## ADDENDUM NOTICE #1

**DATE:** Sep 12, 2025

**PROJECT:** Well Installation at Miesville Ravine Park Reserve

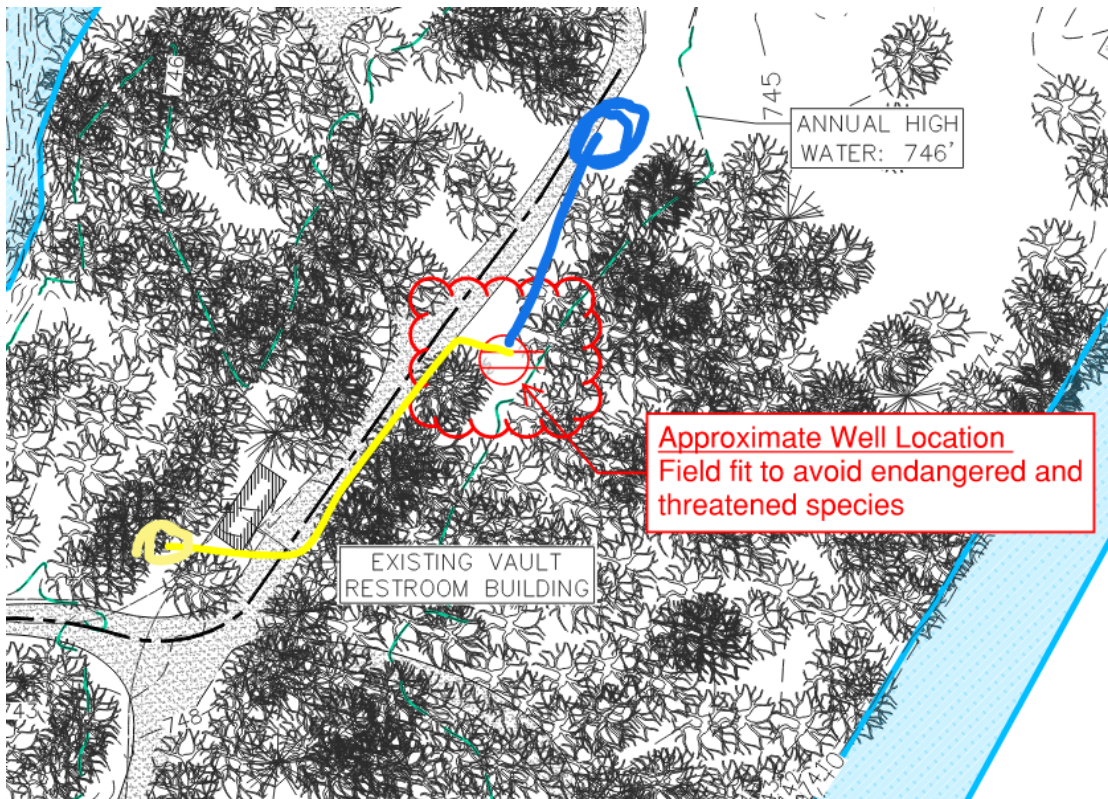
6. Q: Please show the water supply, and power supply locations and distances to the well

A: The well will be approximately 80ft of waterline and 150ft of electric conduit. See the lower line on the left (yellow line) for electrical conduit and the upper line on the right (blue line) for waterline.
